Proposal for amendments regarding WP.29/2022/59

Modifications to the existing text of UN-Regulation No. 157 are in **bold** for new or ~~strikethrough~~ for deleted characters.

Japan modifications to the existing texts of UNR157-15-03r1 are highlighted in **red bold** for new or ~~red-strikethrough~~ for deleted characters.

Model A

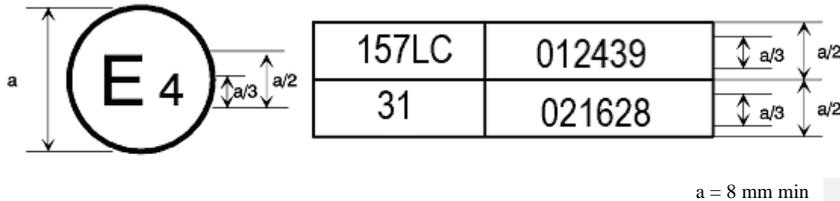
The above approval mark affixed to a vehicle shows that the vehicle type concerned has, with regard to ALKS, been approved in the Netherlands (E 4) pursuant to UN Regulation No. 157 under approval No. ~~002439~~ **012439** and is capable of a lane change procedure. The approval number

indicates that the approval was granted in accordance with the requirements of UN Regulation No. 157 ~~in its original version~~ with the 01 series of amendments incorporated.
